UNITED STATES PATENT AND TRADEMARK OFFICE

Office Action Summary	Application No. 10/573,199	Applicant(s) OOHASHI ET AL.	
	Examiner ANATOLY VORTMAN	Art Unit 2835

DETAILED ACTION

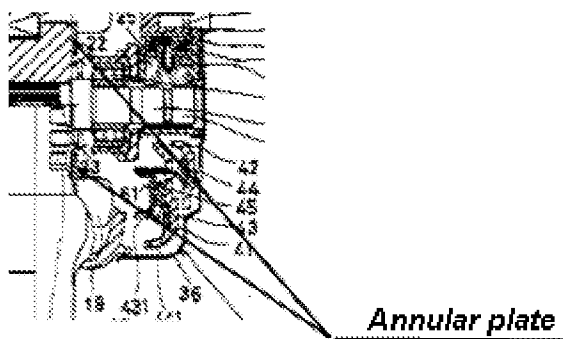
Regarding claim 16, Oiwa disclosed that said fan (19) has an annular plate (not numbered) disposed on an end portion near said circuit board (see annotated fragment of Fig. 1 below):

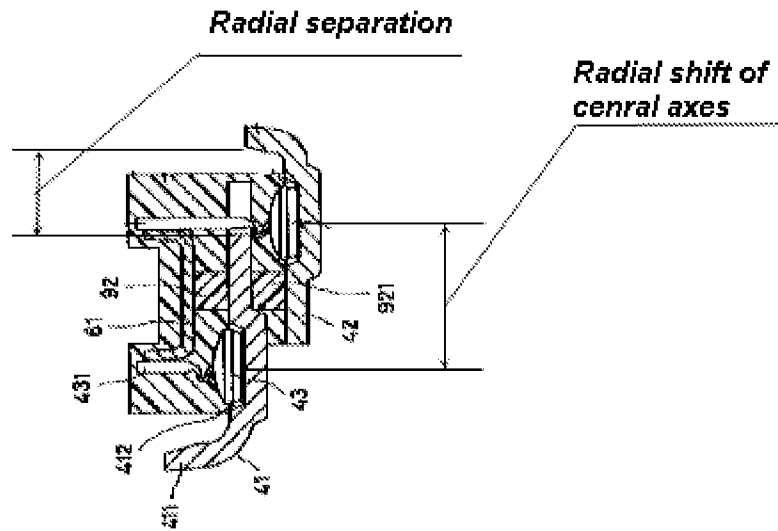
6. Applicant's arguments have been fully considered but they are not persuasive. The gist of the Applicant's arguments is that, allegedly, "Oiwa in Fig. 3 discloses that a second heat sink (42) is disposed so as to be separated axially outward from the first heat sink (41)". Examiner agrees with the aforementioned statement. However, beside being separated axially, said heat sink (42) **is also separated radially** from said first heat sink (41), as clearly shown on Fig. 7 and 8 of Oiwa (see below):

Therefore, claim 14, as amended, still reads on the Oiwa's device and the rejection is hereby maintained.
